GNRO-2002/00012

SUBJECT: Grand Gulf Nuclear Station, Unit 1
Docket No. 50-416
Supplement to Amendment Request Concerning
Control Rod Scram Time Testing Frequency

Response to Request for Additional Information Related to Scram Time Testing Intervals

Revised Markup of Technical Specification Bases Pages

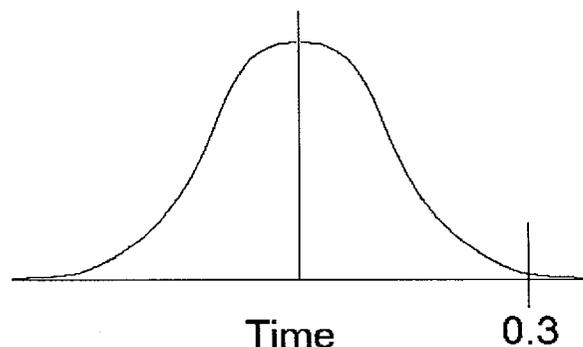
3. Reference, Page 2, last paragraph, second sentence. "An evaluation of the historic average times and standard deviation in time..."

- a) How was the standard deviation calculated?

The standard deviation of scram times was calculated by applying the standard deviation function in Excel to the measured scram times of the database population.
